MODIFICATION INSTRUCTIONS for the **Kodak MINILOADER 2000P** **Service Code: 3479**

Modification No. 10 Type 2

Purpose: To provide positive pressure to the area of the CASSETTE by moving the internal FAN.

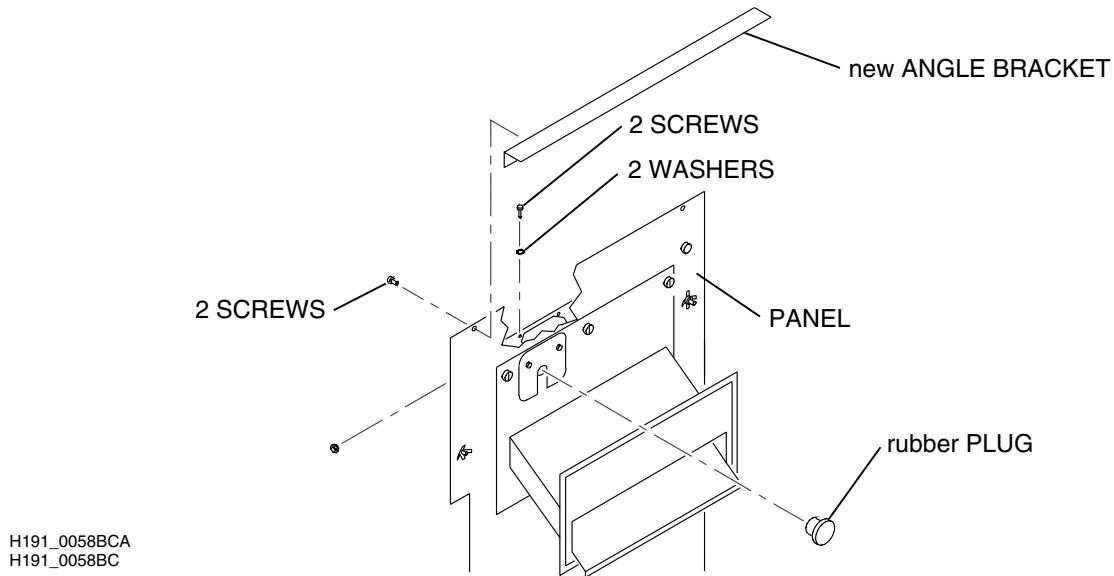
[9] Remove:

- 2 SCREWS
- PLATE
- 2 SCREWS
- 2 NUTS
- FAN AND GRILL AY
- 2 SCREWS

[10] Remove and discard the ANGLE BRACKET.

[11] Install:

- PLATE
- 2 SCREWS
- 2 NUTS

[12] Install the new ANGLE BRACKET to the back of the MINILOADER2000P. Use the 2 SCREWS from [Step 9](#).

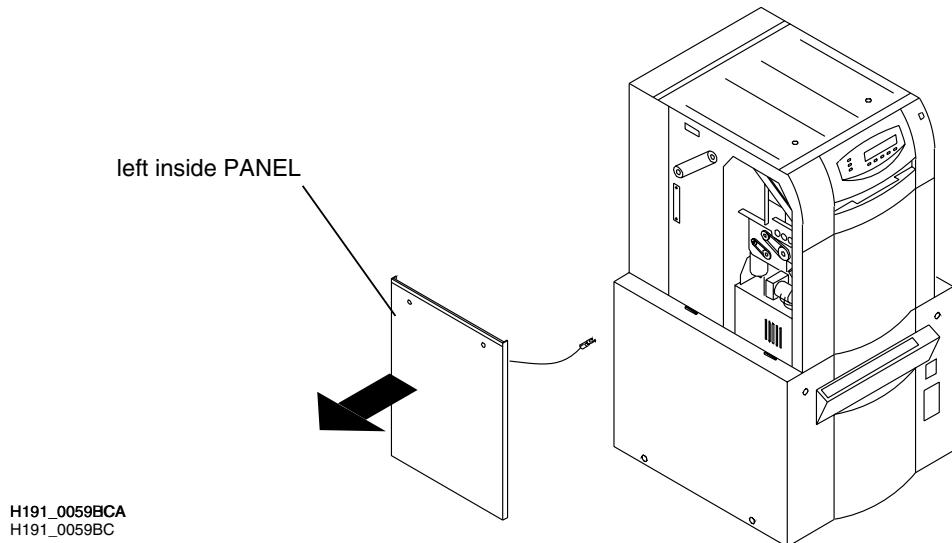
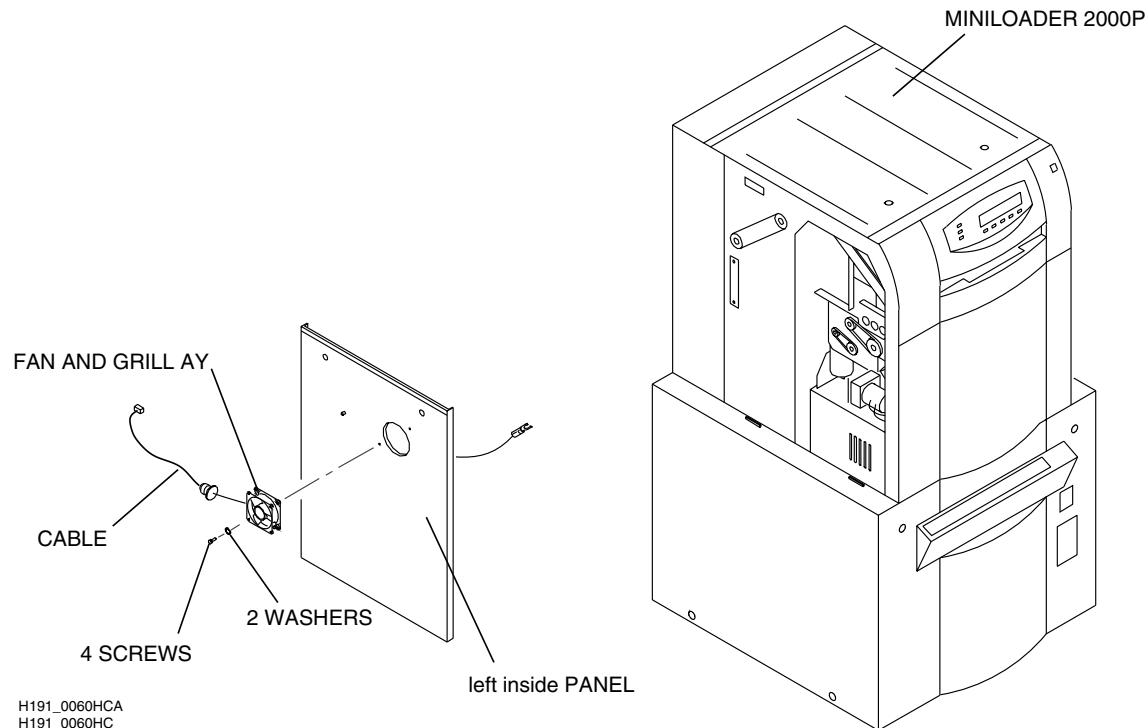
[13] Install in the existing holes on the PANEL:

- 2 WASHERS
- 2 SCREWS
- new rubber PLUG

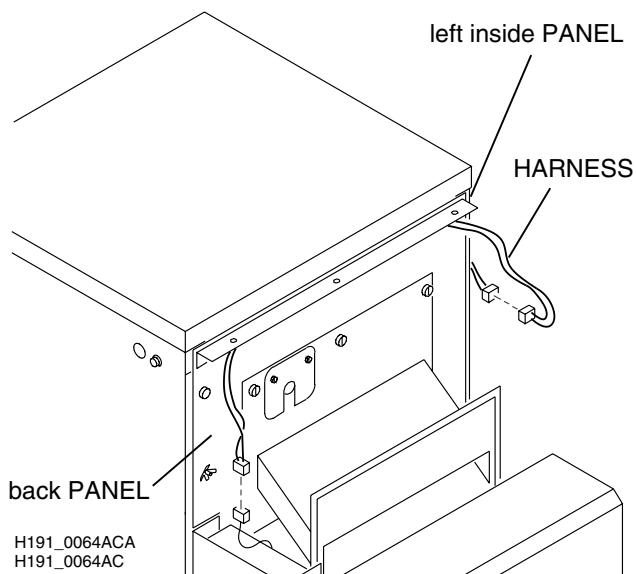
[14] Remove and discard the left inside PANEL.

[15] Install on the new left inside PANEL:

- FAN AND GRILL AY
- 2 new WASHERS
- 4 new SCREWS

[16] Check that the CABLE is toward the back of the MINILOADER 2000P.

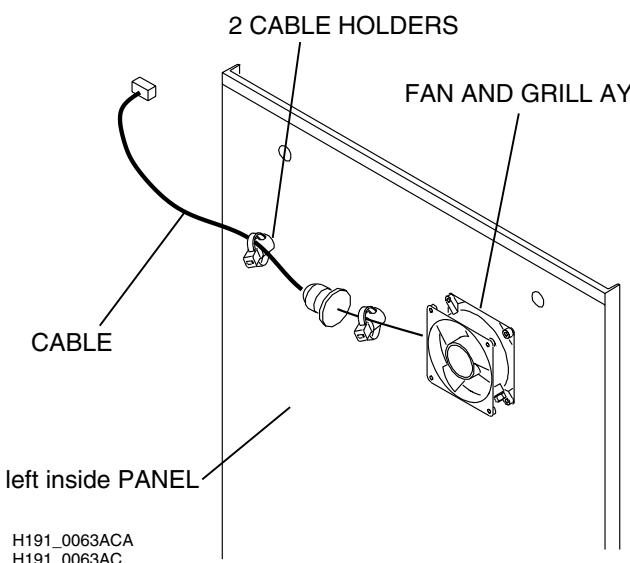
[18] Route the new HARNESS.

[19] Fasten the CABLE for the FAN AND GRILL AY to the 2 CABLE HOLDERS on the left inside PANEL. Use the new TIE WRAPS.
